<p style="text-align: center;">INTERSECTION LIGHTS SERVICE BULLETIN</p>	UP 124B REV 1 2016-02-25
		Page 1 of 1

AMBULANCE TYPE: MX151D

TITLE : INTERSECTION LIGHT « STEADY-BURN » DEACTIVATION FEATURE (UNIT 63030 TO 63092, 63100 TO 63164, 63200 TO 63264)			
DATE : 2016-04-13	DRAW. : Y. DUBÉ	# DRAWING : # 00995	REV : 1
# ASS :			PAGE : 1/6

Diagram 1.0

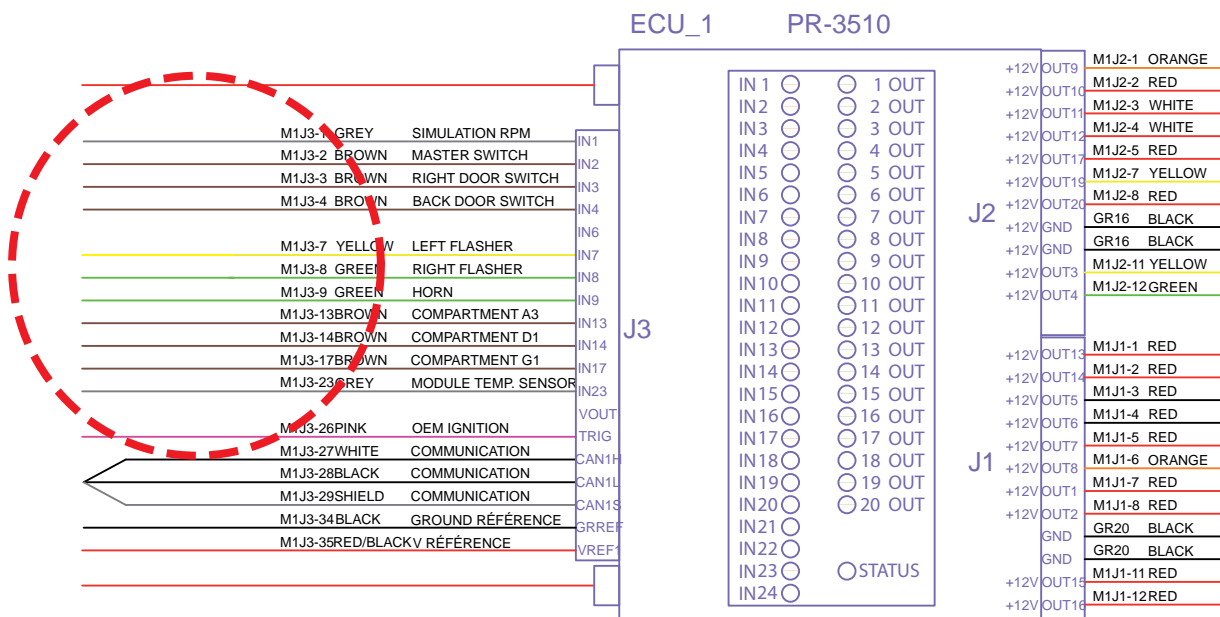
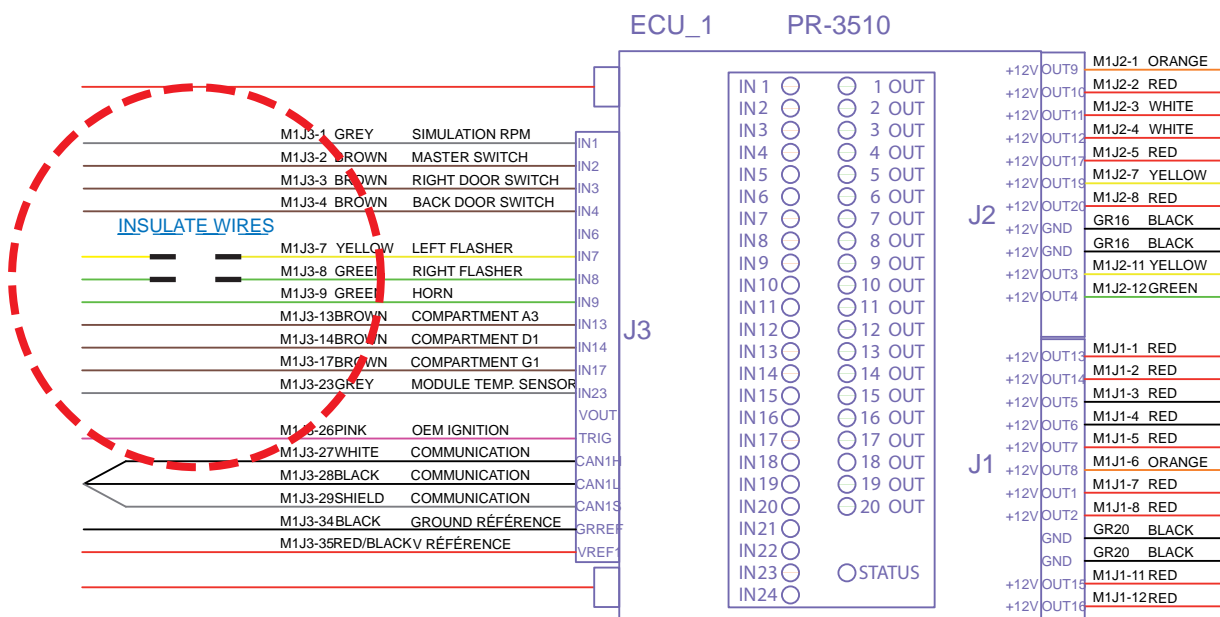
This bulletin is to inform owners of Demers Ambulances (unit numbers listed above) that a modification of wiring harness is required. Front fender intersection lights are activated with the left/right flasher and with emergency lights. Modification will consist of removing left/right flasher feature but emergency lights feature will remain functional.

- 1 - Locate connector J3 on module ECU-1.
- 2 - Remove connector J3 and locate pin 7 - left flasher / pin 8 - right flasher (see diagrams on page 2)
- 3 - Cut and insulate wires at both ends on pins 7 & 8 (yellow & green wires)
- 4 - Reinstall connector J3 on module ECU-1.

Diagram 3.0

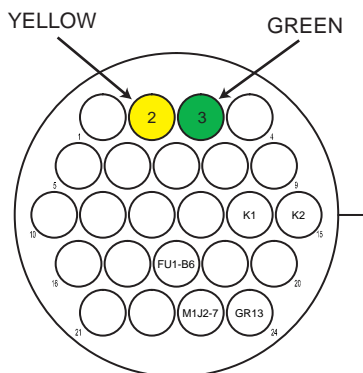
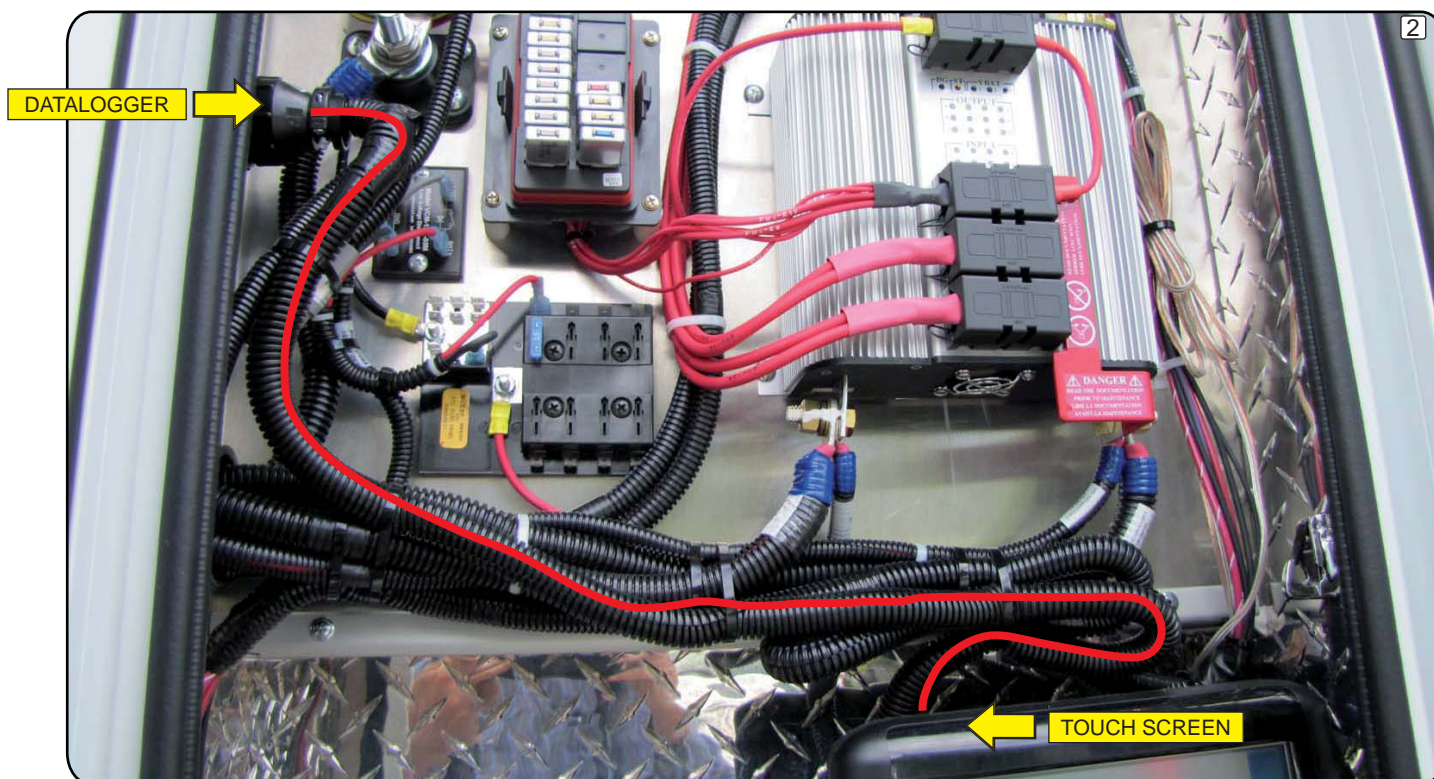
5 - Use supplied wires (H030690) to run from round datalogger plug to touch screen connector.  
(Terminals are different, route them as follows on picture #2)

6 - For the round datalogger plug (Diagram 3.0)

- Connect yellow wire to pin 2
- Connect green wire to pin 3

- For the touch screen connector (Diagram 3.0)

- Connect yellow wire to pin 1 (if there is a wire already, remove it)
- Connect green wire to pin 2

Secure the new harness with tie wrap.
